**INTERNATIONAL STANDARD ISO 7478 : 1987  
TECHNICAL CORRIGENDUM 1**

**Information processing systems — Data communication  
— Multilink procedures  
TECHNICAL CORRIGENDUM 1**

**Ref. No. ISO 7478 : 1987/Cor.1 : 1989 (E)**

Clause A.2 MLP reset initiated by a single station

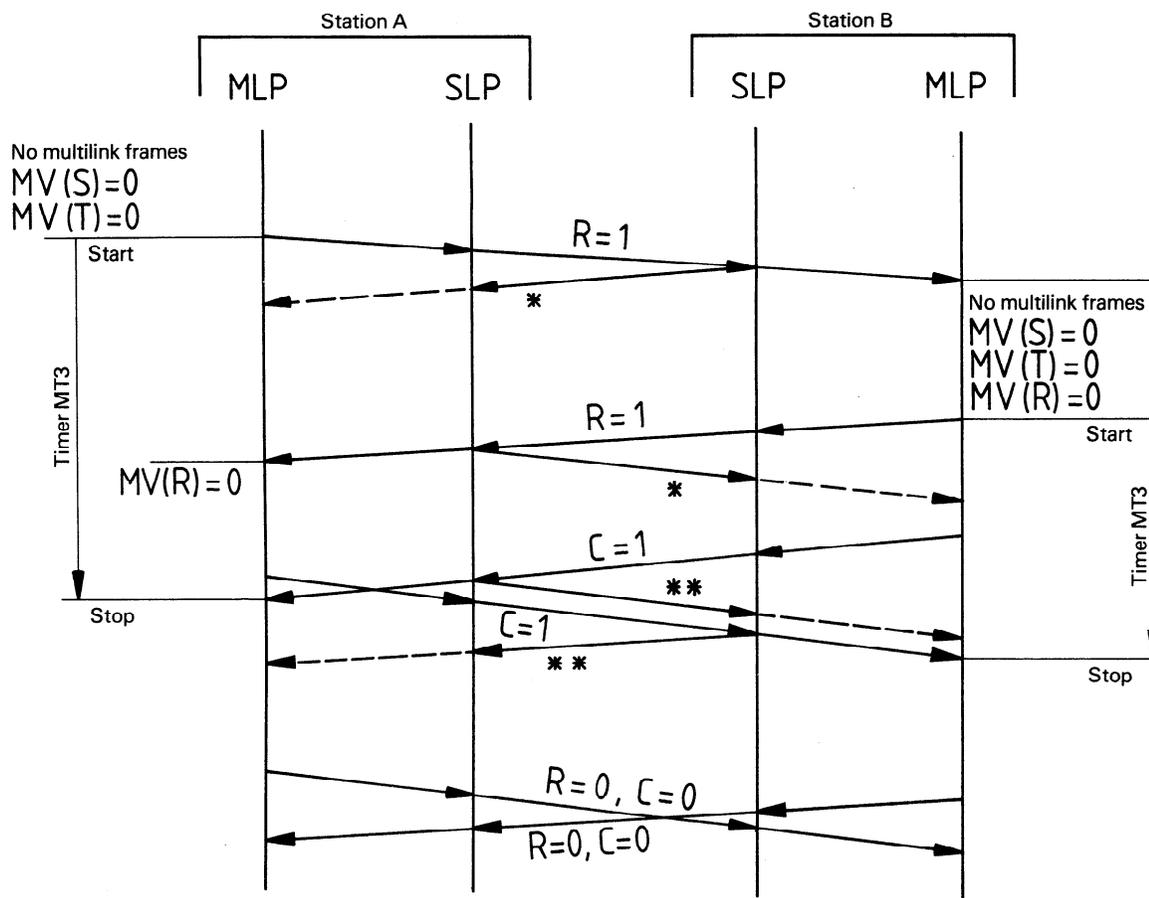
The change is required to correct a potentially misleading diagram.

Replace the diagram with the following:

\* The SLP frame that acknowledges delivery of the multilink frame with  $R = 1$ .

\*\* The SLP frame that acknowledges delivery of the multilink frame with  $C = 1$ .
